REQUEST FOR ADDITIONAL INFORMATION

MARK I CONTAINMENT LONG TERM PROGRAM

PLANT UNIQUE ANALYSIS REPORT

BRUNSWICK STEAM ELECTRIC PLANT

Fig. 1 DIMENSIONS

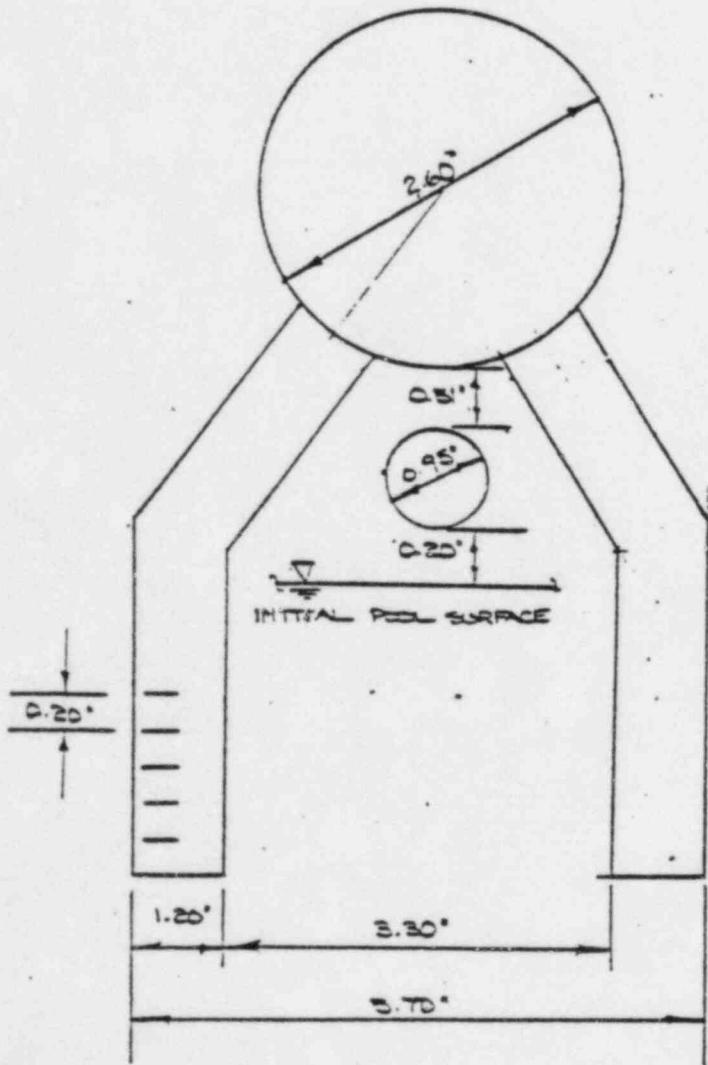
The QSTF plant-specific movies were utilized in the calculation of the froth impingement loads, as allowed by the AC, on the RHR test lines, RHR containment cooling line and the monorail. Which QSTF tests were used? Describe how a conservative load specification was achieved and what uncertainty limits were applied as discussed in the AC. Discuss in detail the method used to determine the froth source velocity. Were Region II froth loads considered as part of the PUA?

3. A frame prior to downcomer discharge was frozen. Figure 1 lists the distances between the downcomers, diameters of the vent header, downcomers and deflector that were measured to determine the scale factor between the QSTF and the film. The scale factor for the Brunswick QSTF was taken from Reference 1.

Fig. 5 Pool Swell Height vs Impact Time

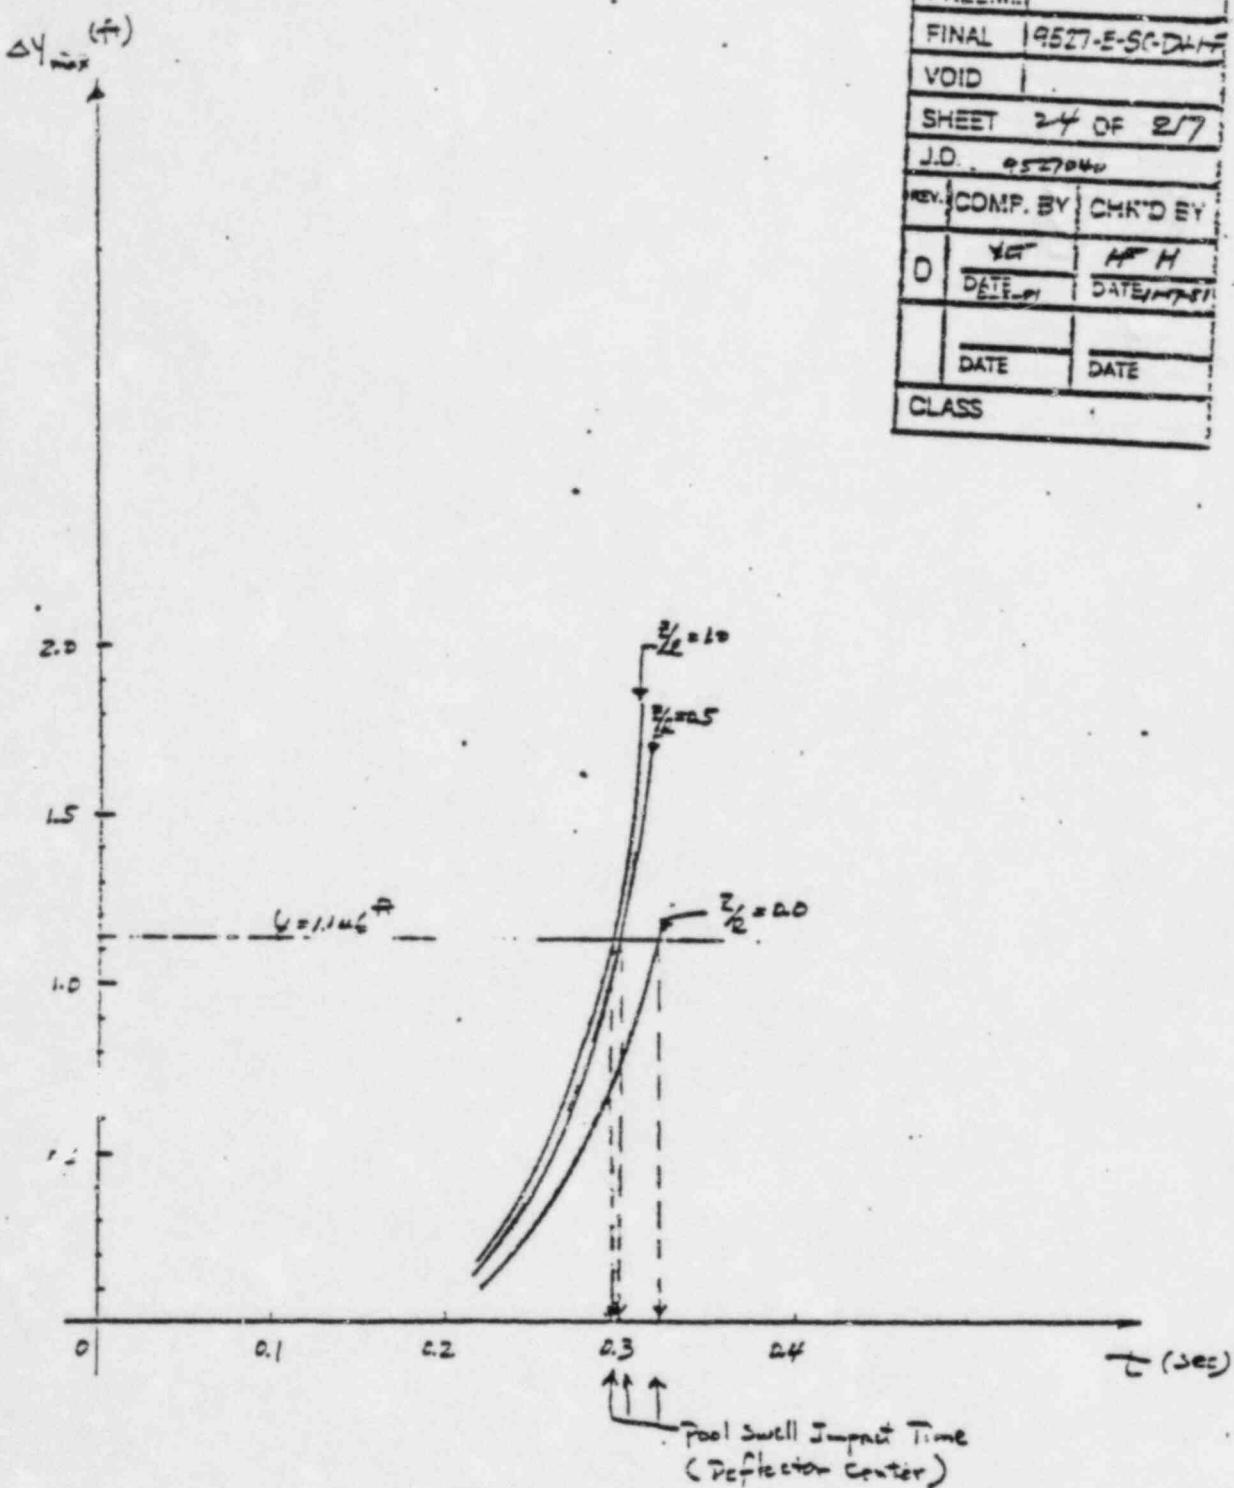
- RAI 8a (Continued)
the AC specification that the three-dimensional load variation shall be based on the EPRI "main vent orifice" tests. Describe in detail how the vent deflector forces were calculated at the various Z/L's.

3. Figure 5, Attachment RAI 8a-1, show the Pool Swell Height versus Impact Time curves at Z/L locations, 0, 0.5 and 1.0. These curves were based on the Pool Surface Displacement Longitudinal Distribution curves shown in Figure 4.3.4.2 of the LDR and the Plant Pool Surface Displacement curves (PULD). Data for intermediate Z/L stations were linearly interpolated from the generated curves. This process, similar to that described for Figure 8-3, Attachment RAI 8a-3, was taken into account for the effect of impact time delay.

Figure 3-21. Pool Surface Velocity and Acceleration Multiplier as a Function of Longitudinal Location (Reference 7)

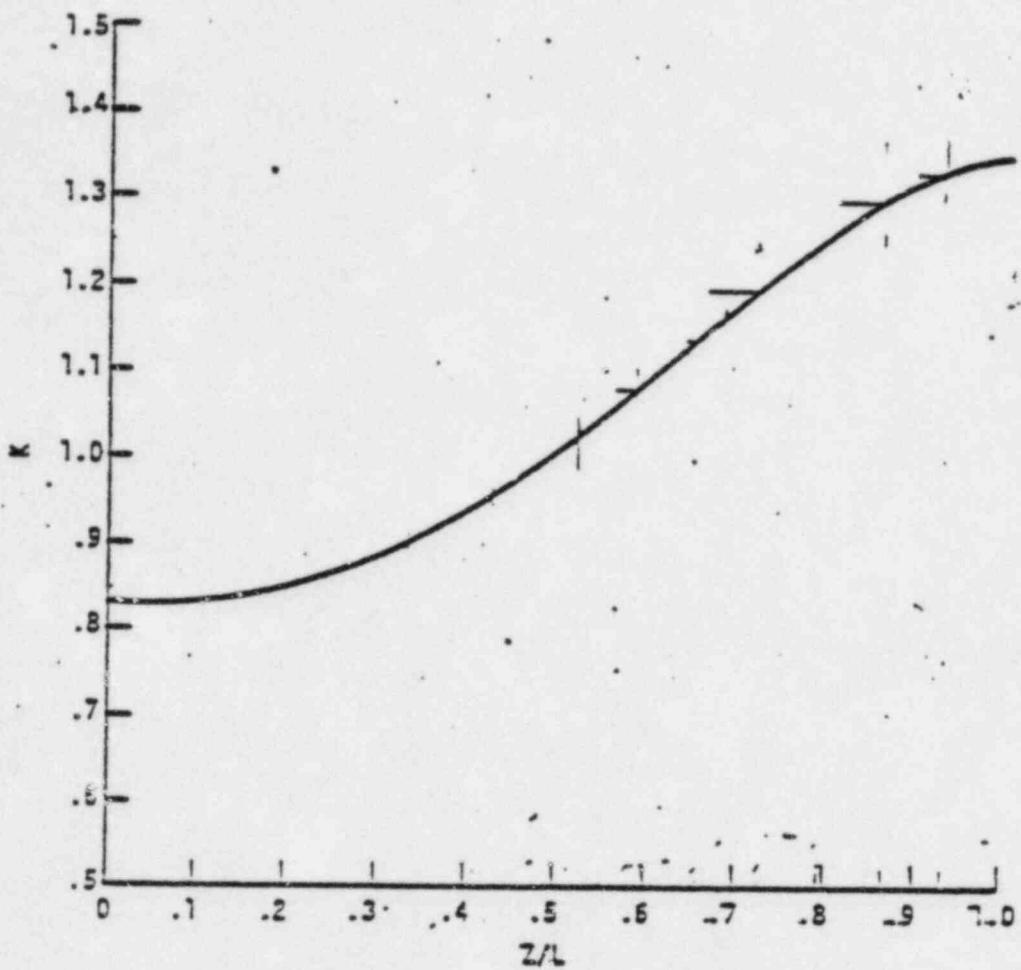
- RAI 8b PUAR Section 3.3.2.3, AC Section 2.10.1
Specify as part of your response which longitudinal multipliers and set of equations were used in the interpolation process.

The longitudinal multipliers shown in Figure 3-21 of NEDO-24612, Attachment RAI 8a-2, and set of equations given in the response to RAI 8a were used in the interpolation for PUAR.

Fig. 11 Loads at $z/L = 0.792$

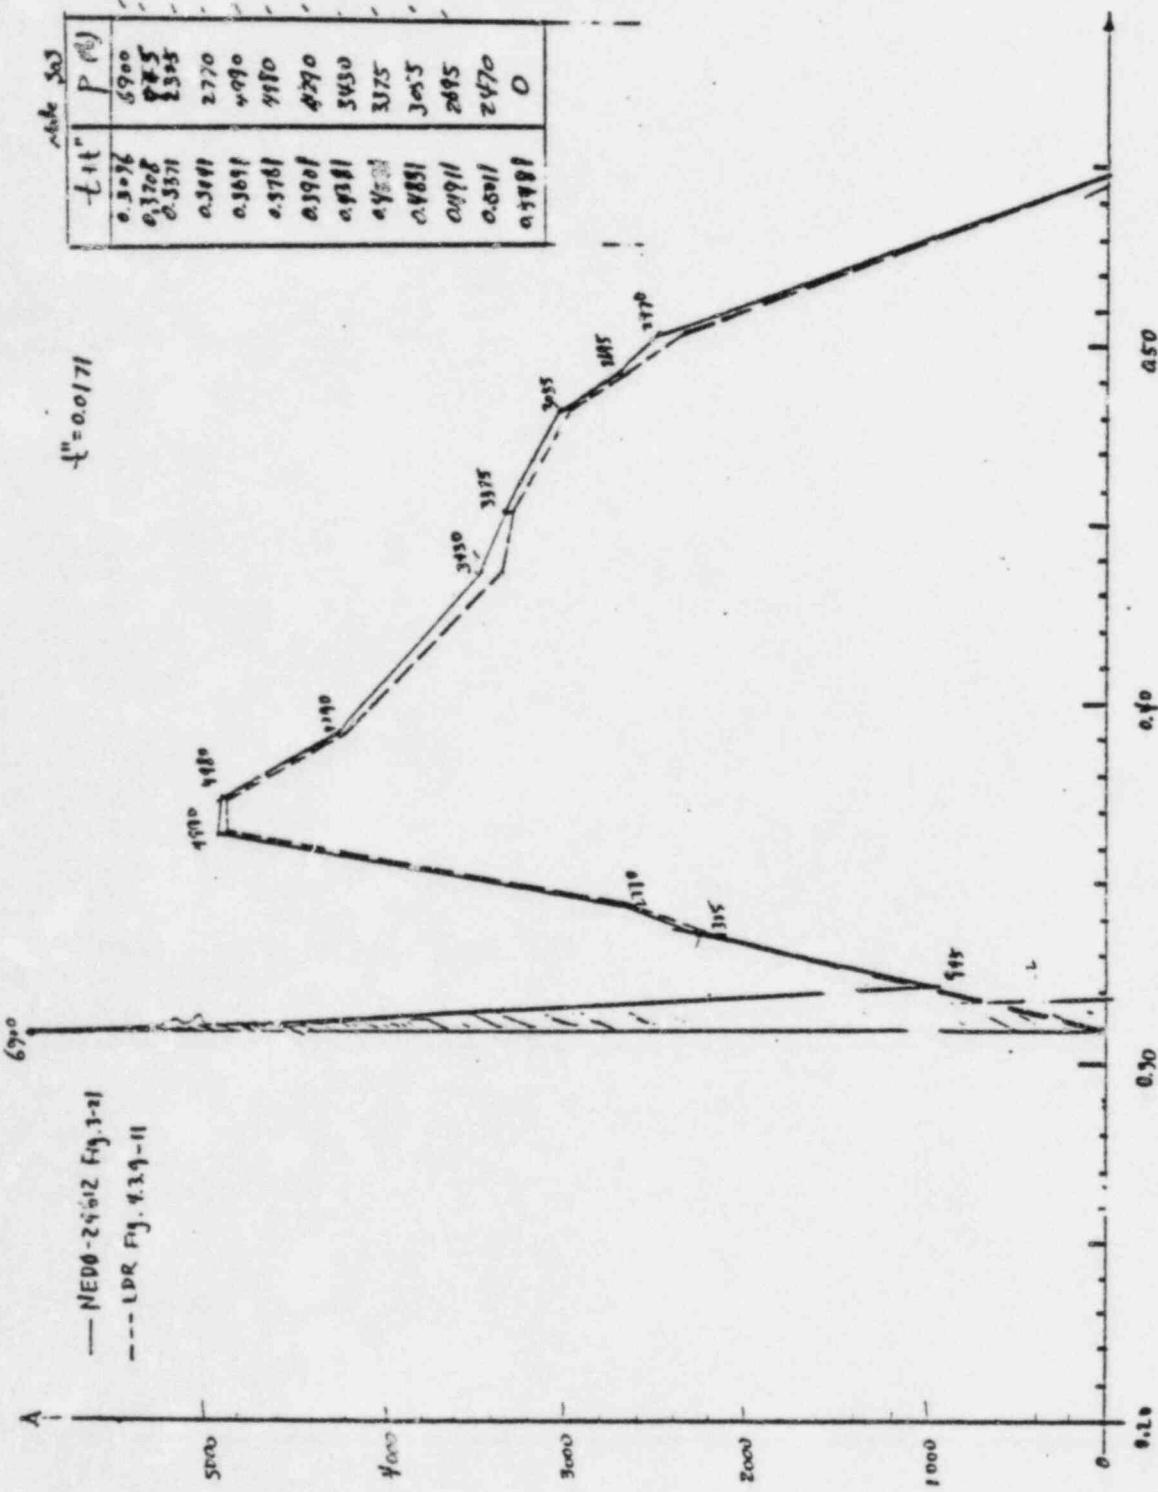
In addition, specify what the Z/L is for the typical pool swell impact and drag load given in Figure 3.3.2.3-1 of the PUAR.

The Z/L for the typical pool swell impact and drag load given in Figure 3.3.2.3-1 of the PUAR is 0.792 as shown in Figure 11, Attachment RAI 8b-2.

Figure 13-1 Maximum Pool Swell Height

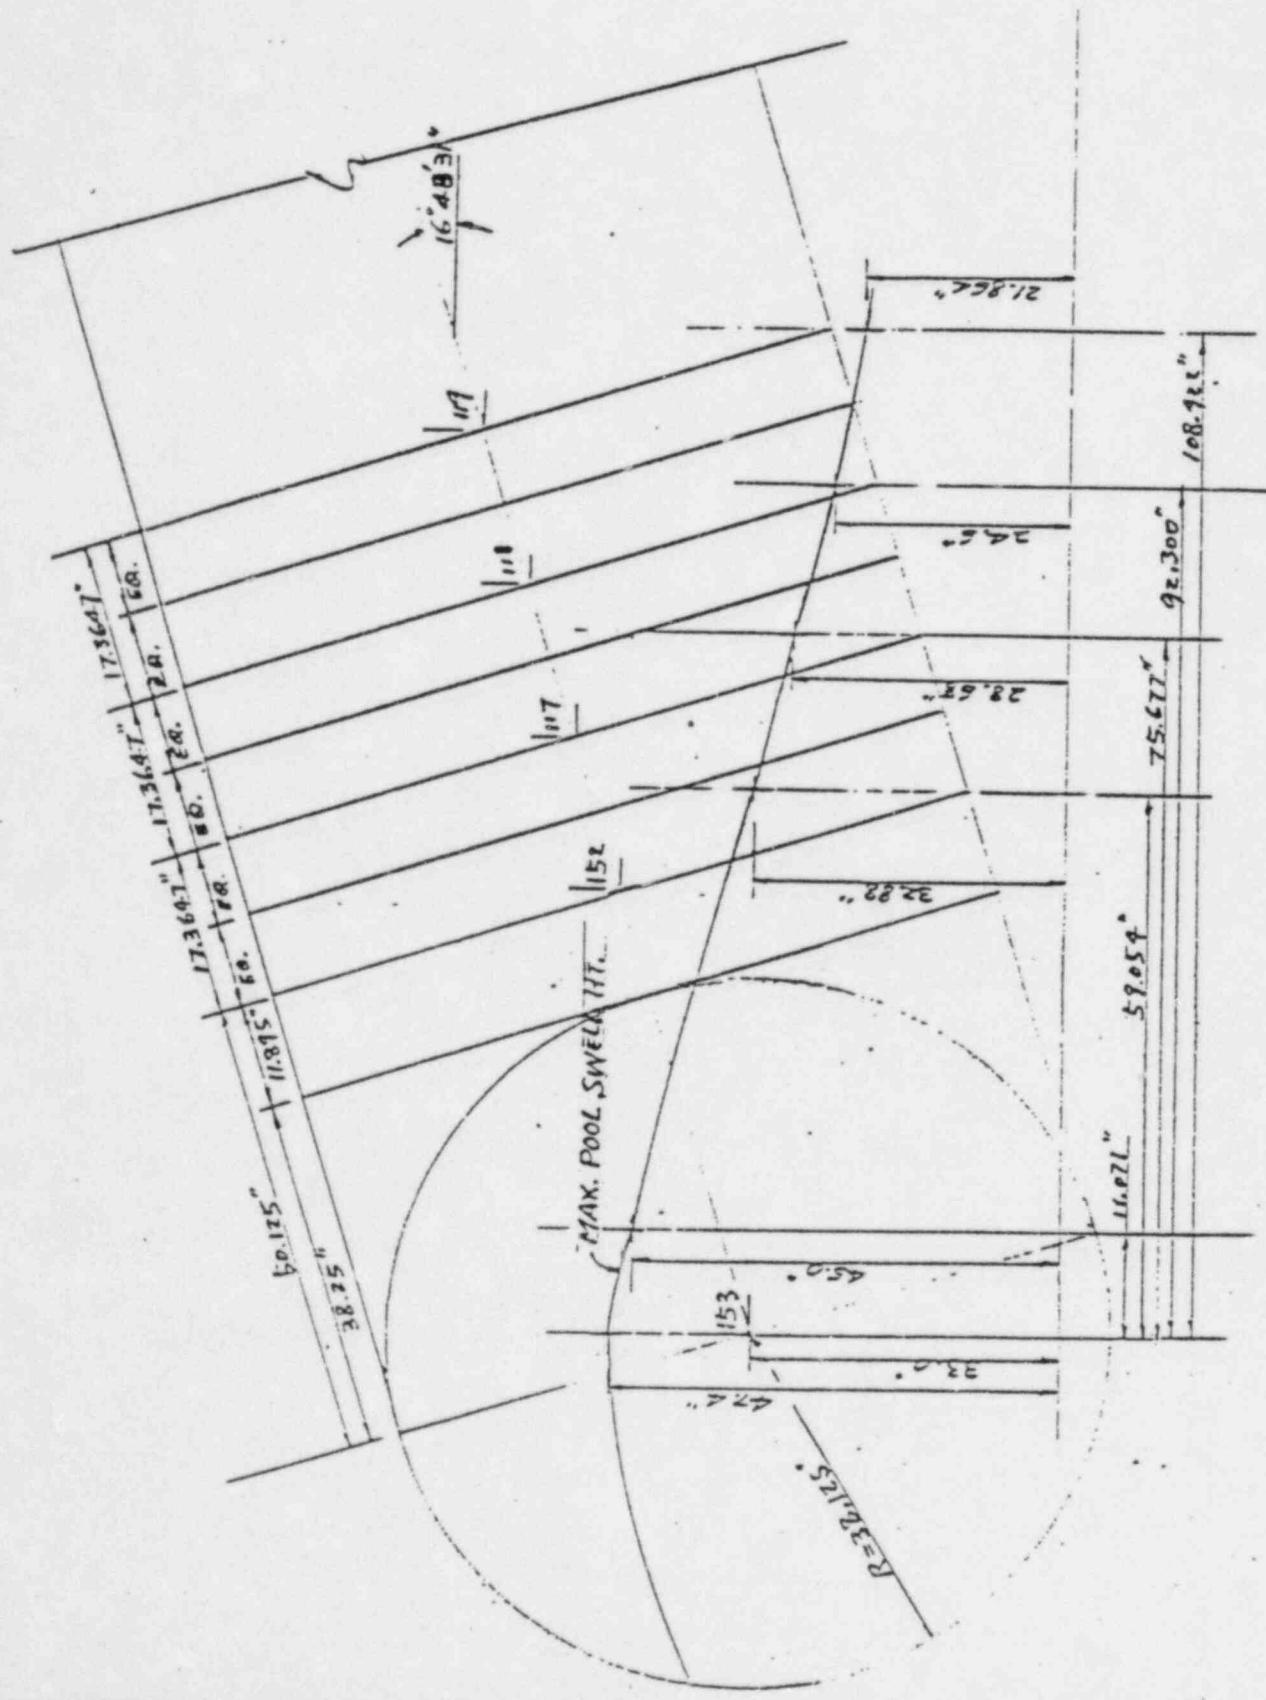
- RAI 13a Provide the impact/drag load transients used in the analysis of the main vent, vent header, vacuum breaker and downcomers.
- RAI 13b In addition, provide the position of the maximum pool swell height and its relation to the main vent.
- RAI 14 Provide the loads that were used in the Torus attached piping.

Figure 13-1, Attachment RAI-13b shows the position of the maximum pool swell height and its relation to the main vent.
